SR-2 – ADVISORY STAFF REPORT (08-07-2026)

ADDRESS: 3418-3426 JOHN R

APPLICATION NUMBER: HDC2026-00381

SCOPE: DEMOLISH REAR WALLS, ERECT ADDITION, REHABILITATE THREE UNITS

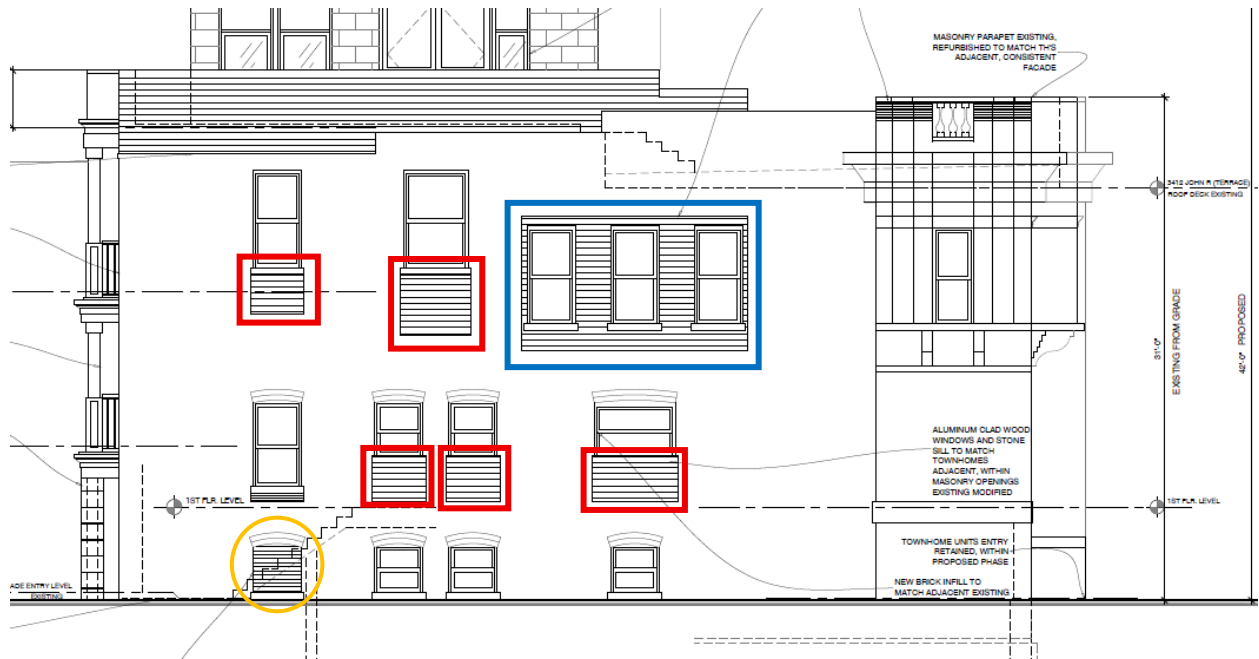
- Also proposed on the north wall along the alley is to: (1) remove the bay window at the second floor to replace it with three individual windows, not in a bay; (2) infill brick around where the bay window had been; and (3) to infill one basement window opening, to partially infill three first-floor window openings to reduce their heights, and to partially infill two second-floor windows to reduce their heights. Staff finds that the building's red-brick walls are secondary instead of primary. The north wall, along the alley, is quite visible from further north on John R, but staff still considers the wall to be secondary. The Guidelines state that it is not recommended to change the number or size "of windows on primary or highly-visible elevations which will alter the historic character of the building." Staff acknowledges that the north wall is highly visible, but, presuming that salvaged brick from the proposed demolition or matching brick can be used for the infill, staff does not find that the proposed alterations will alter the historic character of the building.

The bay window on the north wall, along the alley, (from below) that is proposed for removal. It is currently covered in metal siding that looks like brick. (Staff photo, July 2026)

The proposed north wall alterations, from applicant's materials. Five windows on the second and first floors above the basement are proposed to be reduced in height and infilled with bricks (red outlines), and the bay window is proposed to be removed and infilled with bricks around three replacement windows not in a bay (blue outline). A basement window is proposed to be infilled as well (outlined in yellow). (From the application materials with staff mark-ups.)

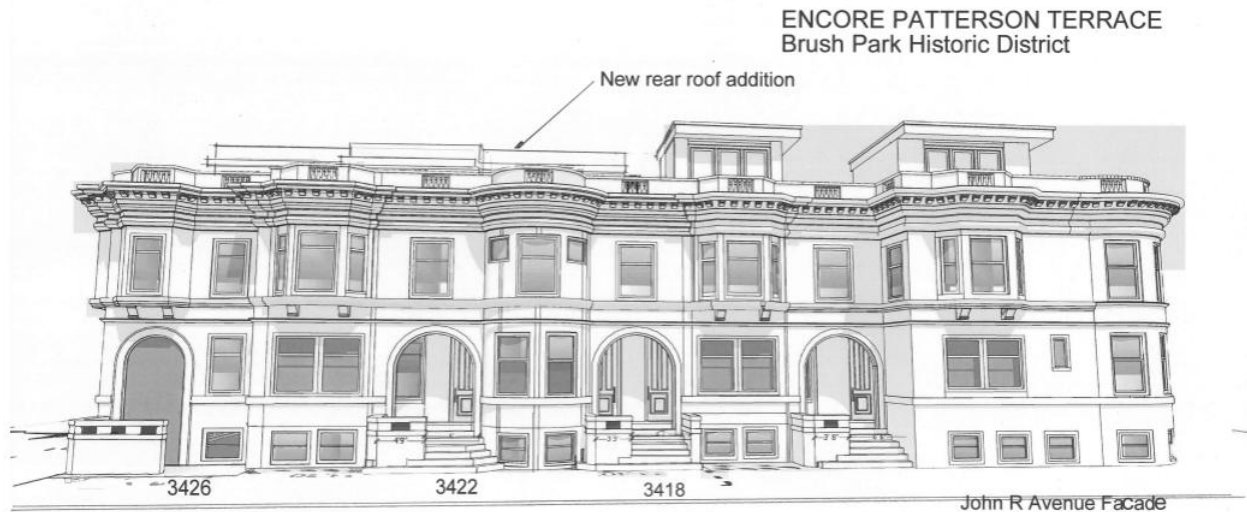
- Standard 9 continues, "The new work shall be differentiated from the old and shall be compatible with the massing, size, scale, and architectural features to protect the historic integrity of the property and its environment." Staff finds that the proposed new construction's height, architectural features, color, and materials are not compatible with the historic integrity of this property and its environment. Building a rear wall that is simpler and more utilitarian than the primary facades of a building was a common historic building practice. The historic-age rear portions of this building are indeed simpler and more utilitarian than the elegantly detailed primary elevations. Demolishing modest, discrete, red-brick rear volumes that tucked behind the primary elevations in order to build in their places one large volume that has fluted and recessed box columns, limestone cladding, ornate balcony rails, and that is one story taller than the historic building does not, in staff's opinion, meet the compatibility requirement of Standard 9.

always be clearly differentiated from the historic building and be compatible in terms of mass, materials, relationship of solids to voids, and color.” They also state that it is recommended to place “new additions such as balconies...on non-character-defining elevations and limiting the size and scale in relationship to the historic building.” The 2017 updated Guidelines state that it is not recommended to construct a “rooftop addition on low-rise, one- to three-story historic buildings that is highly visible, overwhelms the building, and negatively impacts the historic district.” The updated Guidelines also state that it is recommended to ensure “that the addition is subordinate and secondary to the historic building and is compatible in massing, scale, materials, relationship of solids to voids, and color.”

It is staff’s opinion that the proposed new addition is on a secondary elevation, but that it is slightly too tall for the historic building, and that the materials, architectural features, and color are not compatible. There are some limestone-clad buildings on the blocks surrounding the subject building, but the stone is more tan/beige than the proposed product appears (it appears to staff as a fairly bright white), and staff did not observe any similar product that is applied stone tiles. Because this is a rear elevation, it is staff’s opinion that the balcony post designs should be simpler and a non-plastic product (it will be viewed close-up, and even from the ground, the viewer won’t be far away), and that the balcony railings should be simpler. These modifications to the design could help ensure that the rear addition is secondary and subordinate to the historic building. Staff does not find that the proposed rooftop addition overwhelms the building, but the addition does seem tall to staff. The reduction of some height and detailing at the parapet line could help the addition look more in scale with the rear of the building and less visible from the front.

1. The applicant will propose an alternate cladding material and color to more closely reflect the district's Elements of Design and the nearby context in terms of architectural features, materials, and color; the applicant will revise the detailing at the parapet line of the rooftop addition to de-emphasize the addition's height; the applicant will propose simpler balcony posts (in a material other than polyurethane); and the applicant will propose a simpler balcony guardrail, all for staff review and approval, with the goal that the rear addition/rooftop addition will be simplified and more deferential to the historic primary facades.
